15 July 2016

Edition 14

AUSTRALIAN NOTICES TO MARINERS

Notices 744 - 799

Note for chart Aus 249

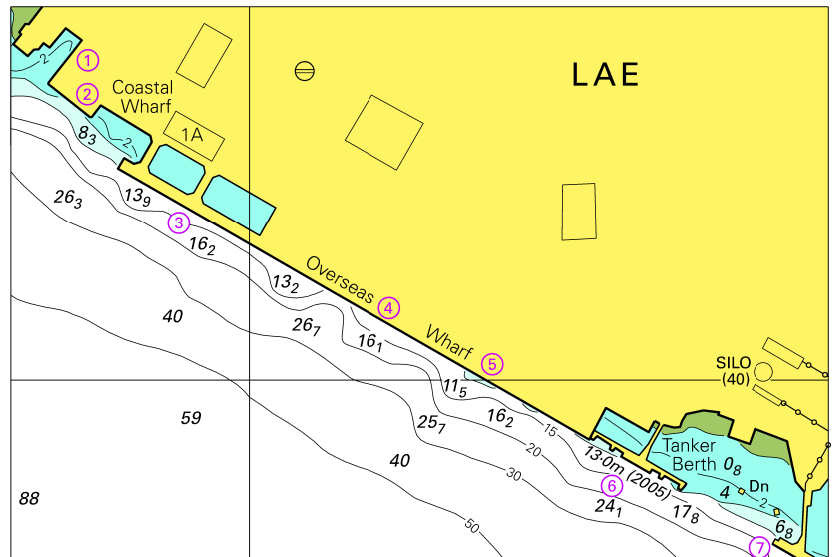
To accompany Australian Notice to Mariners 749/2016

RESTRICTED AREAS

Unauthorised vessels are prohibited from mooring, anchoring or manoeuvring within Areas A and B. Vessels may transit Area B when no large authorised vessels are manoeuvring within the area. Transiting vessels should maintain a listening watch on VHF Ch 10 and 16.

Substitute accompanying RA note 21° 22'.0 S 149° 16'.3 E
